State of New Mexico
 Energy, Minerals and Natural Resources

WELL API NO. 30-015-33527
5. Indicate Type of Lease STATE ☐ FEE ☒
6. State Oil & Gas Lease No.
7. Lease Name or Unit Agreement Name Skeen
8. Well Number 2
9. OGRID Number 372098
10. Pool name or Wildcat Carlsbad; Morrow, South (Gas)

SUNDRY NOTICES AND REPORTS ON WELLS (DO NOT USE THIS FORM FOR PROPOSALS TO DRILL OR TO DEEPEN OR PLUG BACK TO A DIFFERENT RESERVOIR. USE "APPLICATION FOR PERMIT" (FORM C-101) FOR SUCH PROPOSALS.)	
1. Type of Well: Oil Well ☐ Gas Well ☒ Other	
2. Name of Operator Marathon Oil Permian LLC	
3. Address of Operator 5555 San Felipe St., Houston, TX 77056	
4. Well Location Unit Letter <u>P</u> : <u>990</u> feet from the <u>South</u> line and <u>990</u> feet from the <u>East</u> line Section <u>28</u> Township <u>22S</u> Range <u>27E</u> NMPM County <u>EDDY</u>	
11. Elevation (Show whether DR, RKB, RT, GR, etc.) 3130' GL

CONDITIONS FOR PLUGGING AND ABANDONMENT

Wellbore Schematic

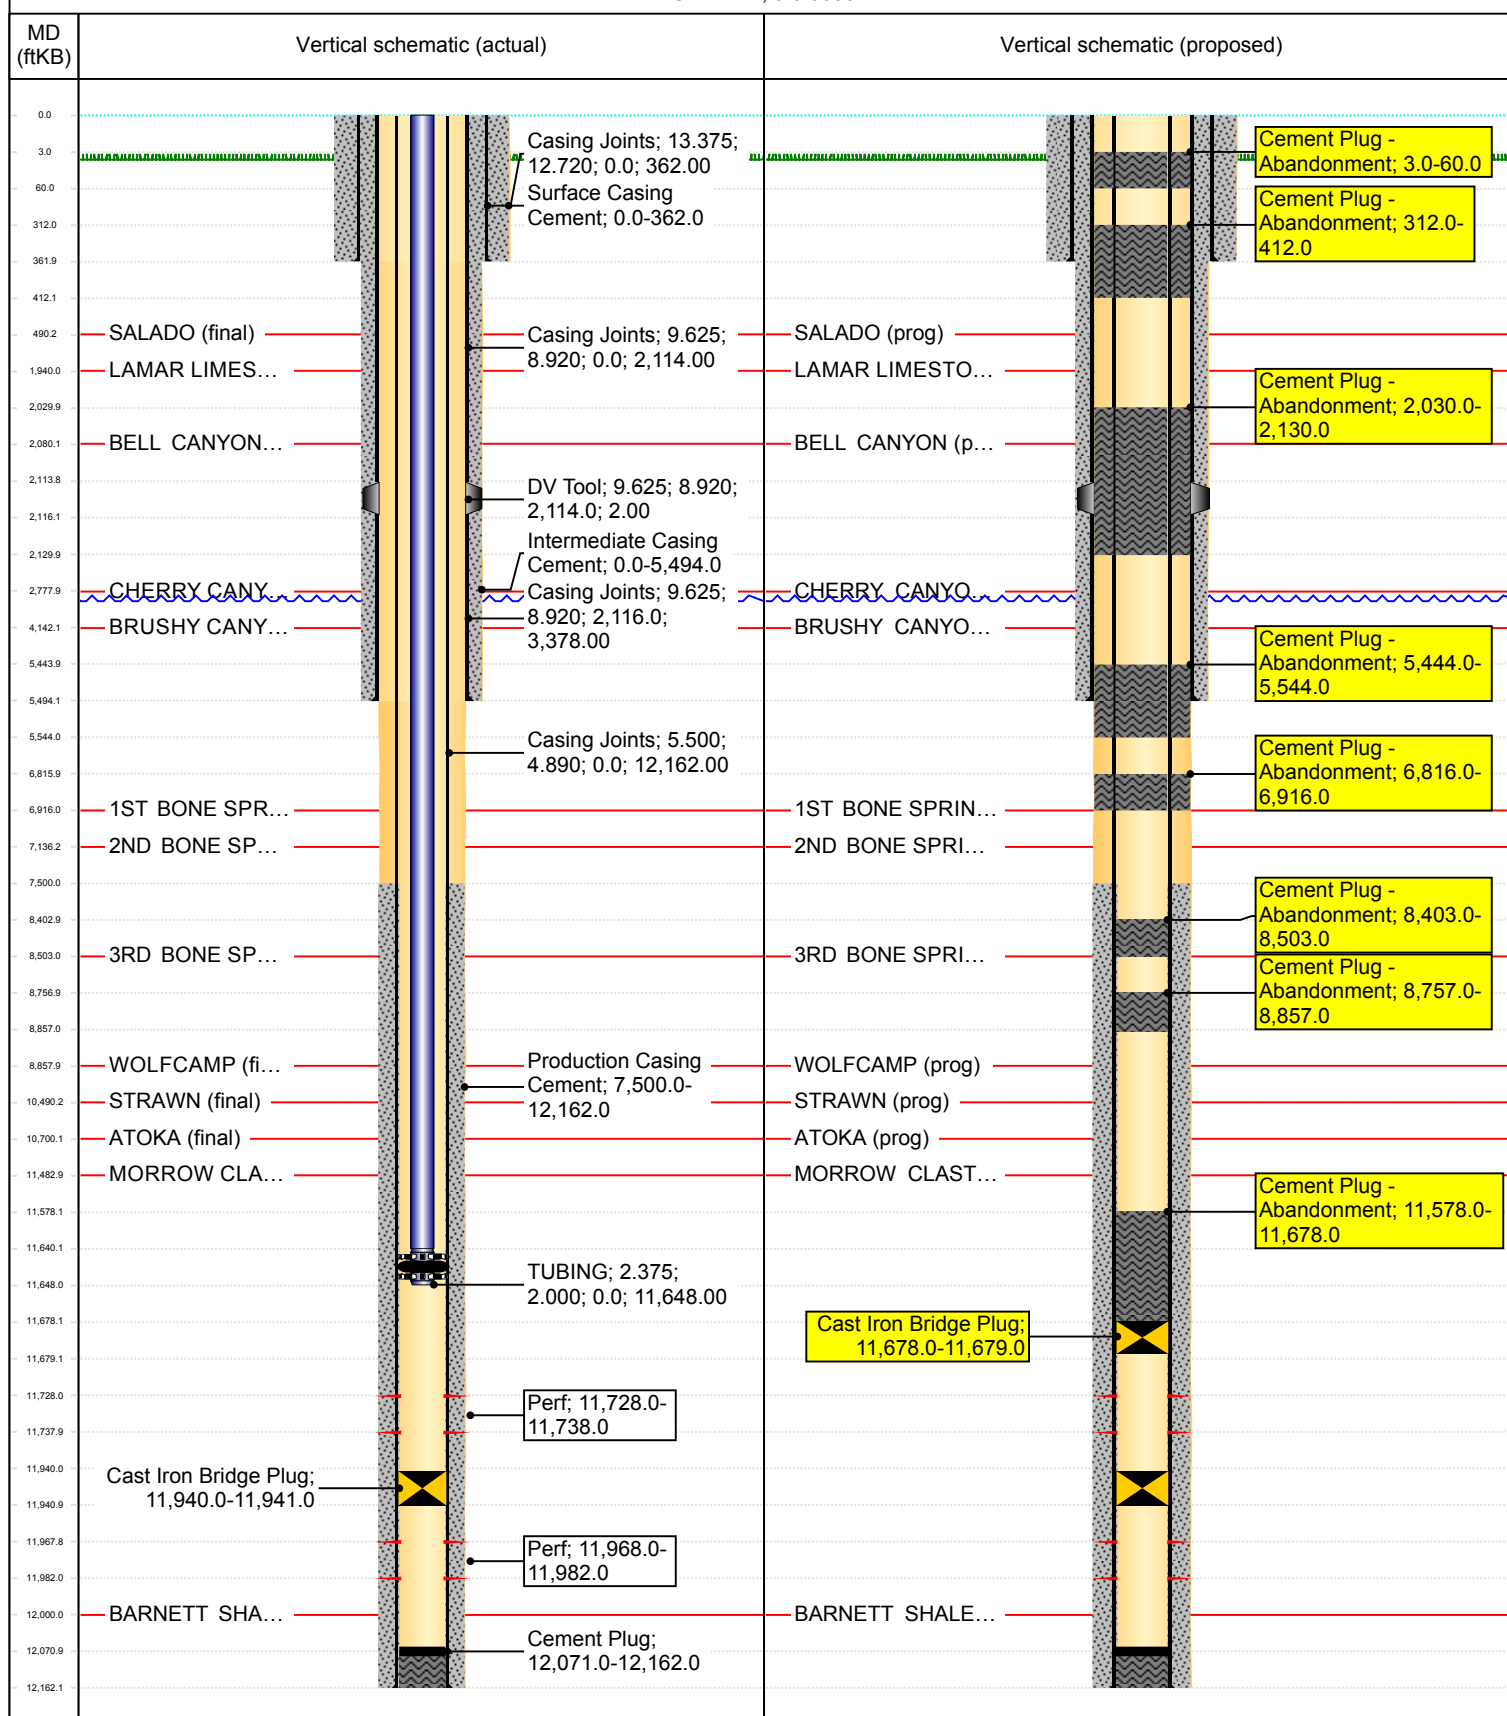
- MIRU NDWH, NUBOP
- POOH with production equipment
- RUWL RIH set CIBP @ 11,678'. Test csg after plug - circ MLF
- Spot 25 sxs @ 11,678'-11,578' Tag.
- Spot 25 sxs @ 8857'-8757'. 8907' - 8807'
- Spot 25 sxs @ 8503'-8403'. 8553' - 8453'
- Perf/Sqz 45 sxs @ 6916'-6816' Tag. 6976' - 6866'
- Perf/Sqz 45 sxs @ 5544'-5444' Tag.
- Perf/Sqz 45 sxs @ 2130'-2030' Tag. 2164' - 2030'
- Perf/Sqz 45 sxs @ 412'-312' Tag.
- Perf/Sqz 25 sxs @ 60'-3'. Verify cmt in all annuli
- POOH, top well off, cut off WH & anchors, install P&A marker.
